LEGEND (ALL CHANGES TO ALL LEVELS)

Note - Detailed internal modifications of the LSH&TM main accommodation building do not form part of this application

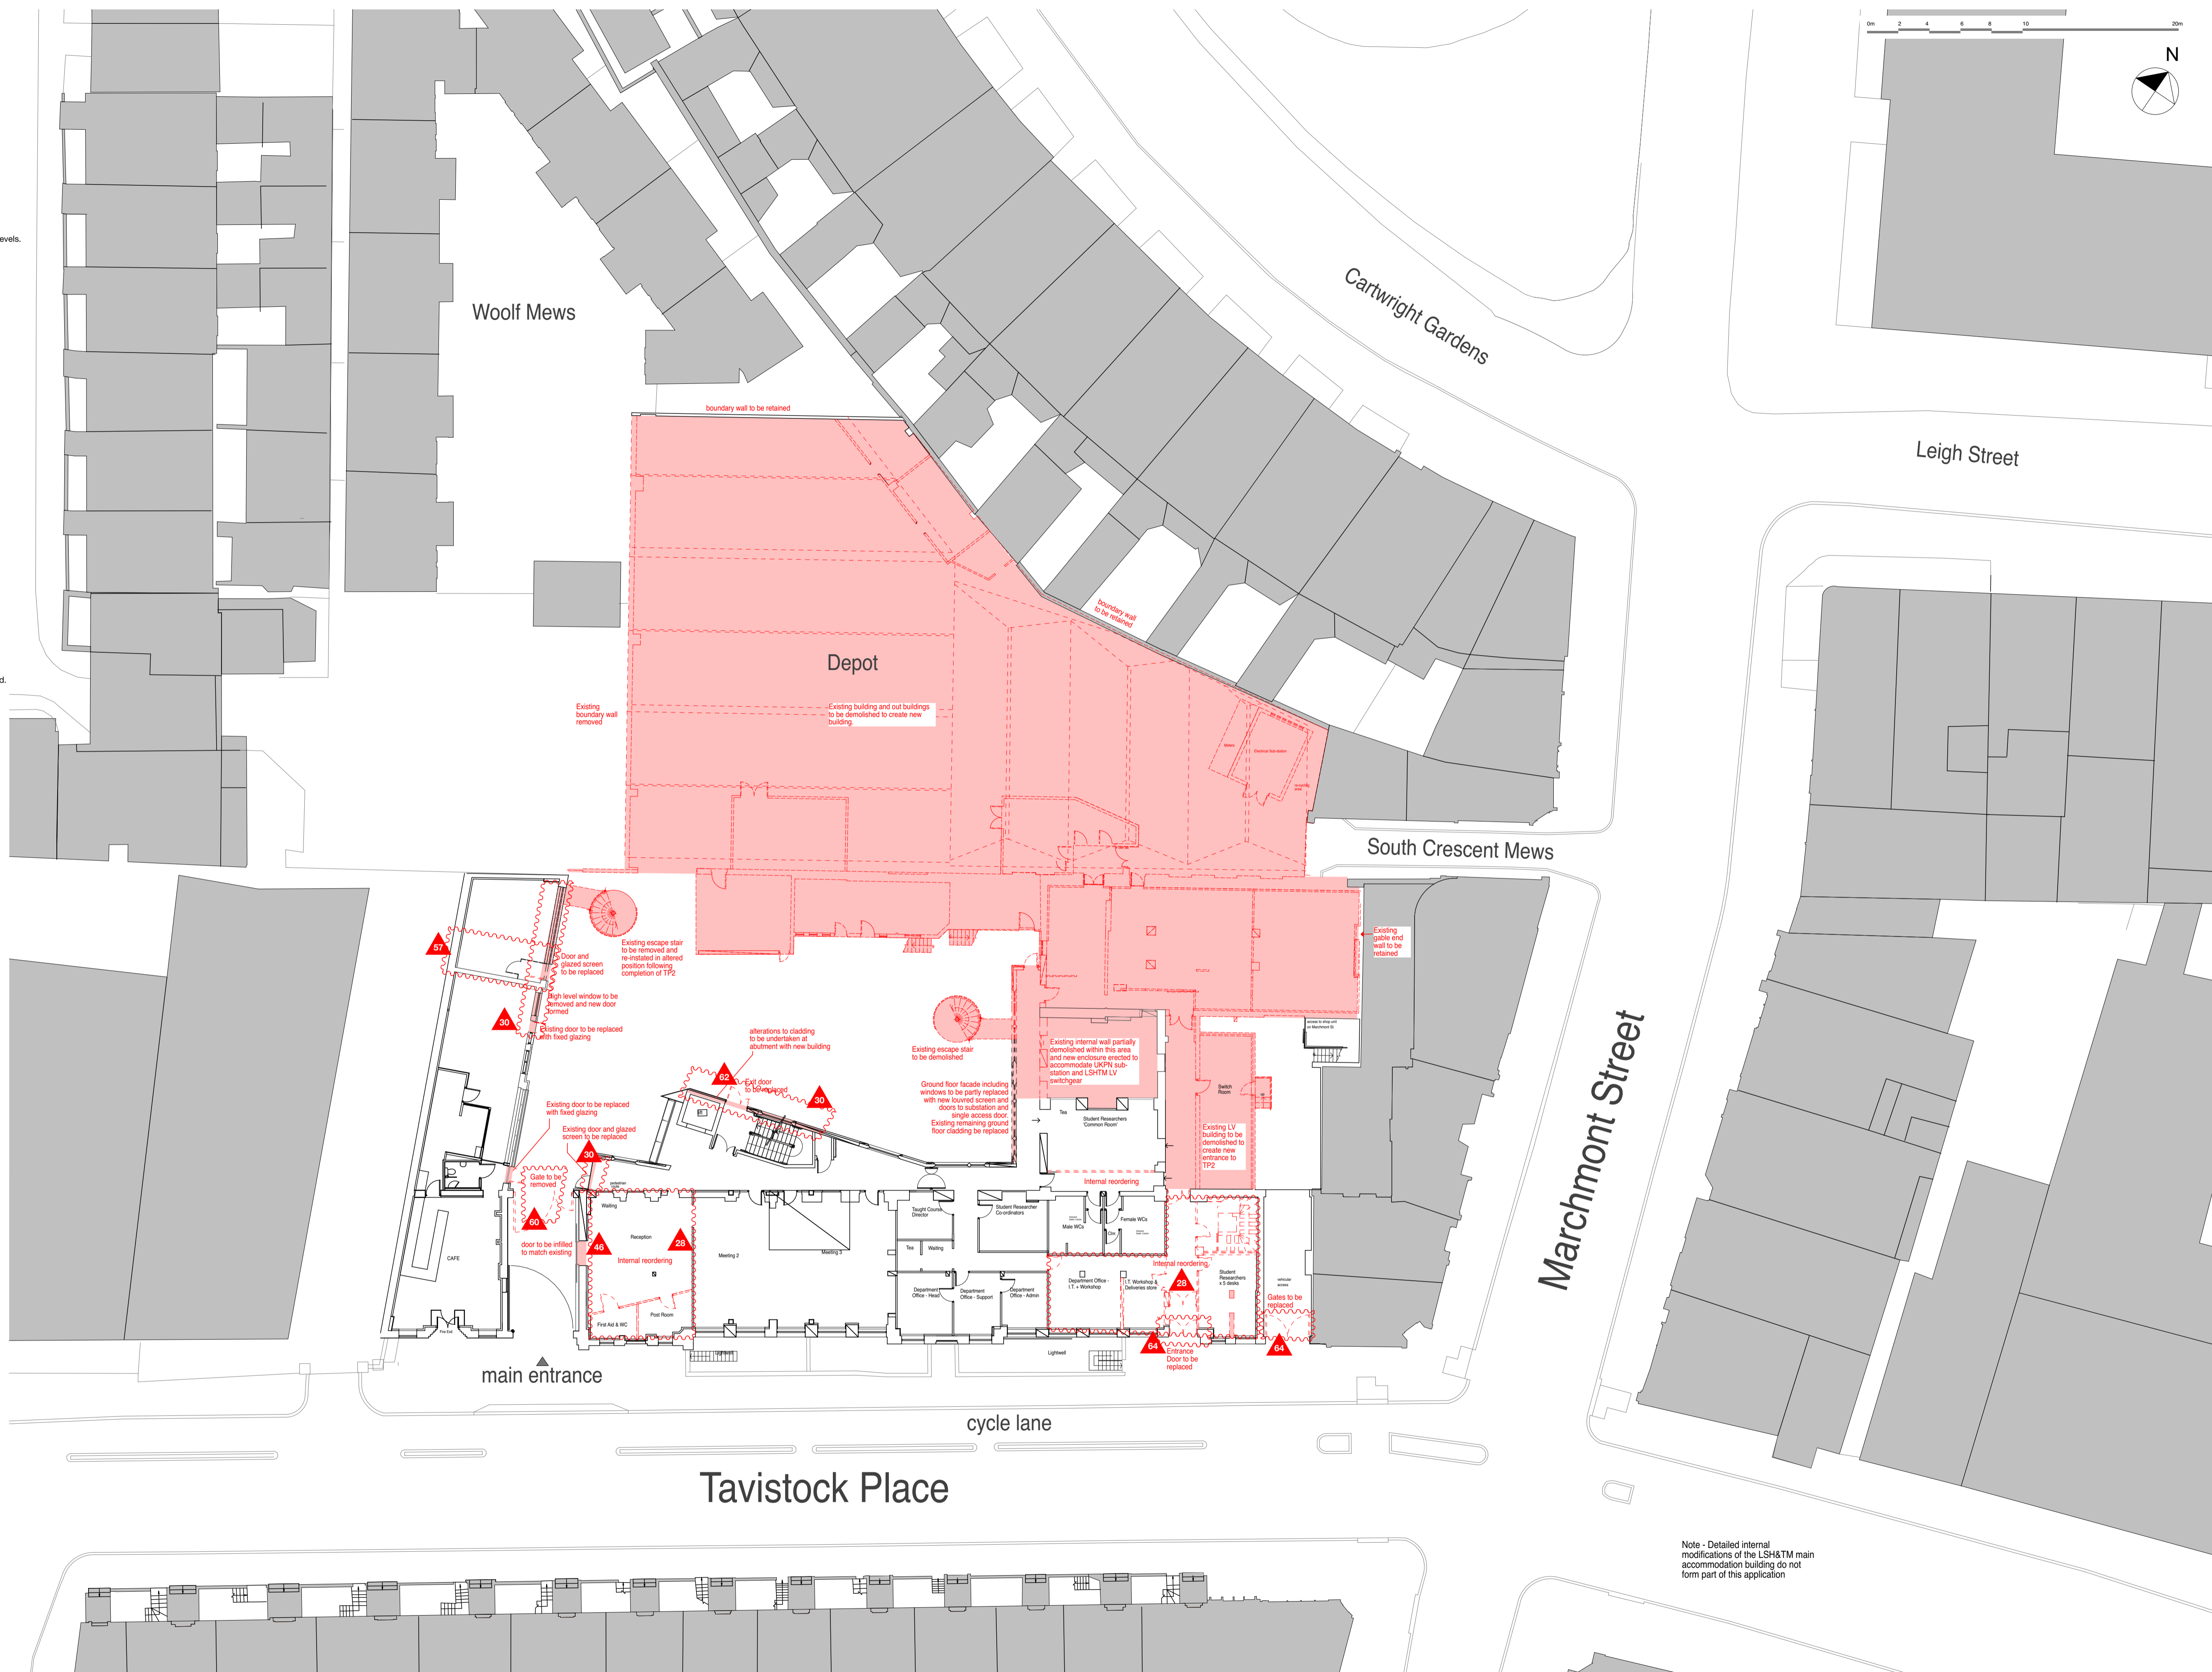
- 01. Stair 2 omitted, and glazed entrance enclosure enlarged
- 02. Window added
- 03. New steps to base of external spiral stair
- 04. Stair 3 roof and gable end arrangement revised.

- 05. Level 3 accommodation mansarded
- 06. Roof light size, height and position adjusted, and smoke vents added.
- 07. Louvres omitted.
- 08. Roof light size, height and position adjusted.

- 09. External ramp adjusted, and railings added.
- 10. West stair core glazing fenestration adjusted to suit amended stair landing levels.
- 11. External paving levels in courtyard raised to achieve required paving falls.

- 12. Low brick plinth added to base of external walls to TP2.
- 13. Brick plinth added to base of existing buildings within courtyard.
- 14. New steps and landing outside room G1.

- 15. Bin store enlarged and repositioned.
- 16. Gallery passageway to TP2: finishes revised.
- 17. Gallery passageway: entrance gates design revised.
- 18. Window on north elevation of TP2 reduced in length.

- 19. Revised turn-table size and position
- 20. Entrance ramp gradient and levels adjusted.
- 21. External levels adjusted
- 22. TP1 west door ramp omitted

- 23. Fall restraint added
- 24. Gates removed
- 25. Maintenance access door added
- 26. Parapet revised
- 27. Roof/wall shape adjusted
- 28. TP1 reception relocated

- 29. Revised door design
- 30. Modifications to windows, doors and facades facing into courtyard.
- 31. Gate details revised
- 32. Revised proposal for bike storage replacing existing bike racks in Dairy shed.

- 33. Gate retained and modified
- 34. Bike canopy detail revised (typical condition highlighted)
- 35. Sub-station doors revised
- 36. Steps adjusted
- 37. Cladding changed to brass finish

- 38. Wall mounted planters revised (typical condition highlighted)
- 39. Steel posts added to boundary wall (typical condition highlighted)
- 40. Height of glazed entrance roof increased to suit required pitch.

- 41. Glazed entrance roof and canopy revised
- 42. New roof guarding to existing flat roof
- 43. Screening fins and cladding added
- 44. Louvres added
- 45. Ramp omitted

- 46. Door removed and infilled
- 47. Access hatch adjusted.
- 48. Depth of green/blue roof build-up adjusted.
- 49. Blue roof incorporated into green roof and gravel margins added.

- 50. Cladding build-up adjusted
- 51. Orientation of brass seams adjusted
- 52. Roof gutters revised.
- 53. Means of escape revisited and exit door added to TP1

- 54. Spiral staircase landings added at each floor
- 55. Door modified
- 56. Basement louvers to external metal staircase landings
- 57. Revised proposal for mean of escape in TP1

- 58. Revised proposal for window and door
- 59. Revised proposal for door to be left as current
- 60. Gate to be removed
- 61. Capping width adjusted and roof planters shown indicatively.

- 62. Door to be replaced
- 63. Revised proposal for the entrance
- 64. Gates and Entrance door in TP1 to be replaced
- 65. Existing stair to be demolished

- 67. Existing window and door to be replaced
- 68. New reconfiguration for new spiral stair and WC
- 69. Staircase partially demolished
- 70. Level adjusted

- 71. Lift pit adjusted
- 72. Level updated
- 73. Red line extended to include South Crescent Mews
- 74. Red line extended to include new ramp and frontage

- 75. Ladder added
- 76. Works to Mews paving/kerbs added
- 77. Minor adjustment to ridge, and eaves line, (not affecting ridge level noted on consented drawings).
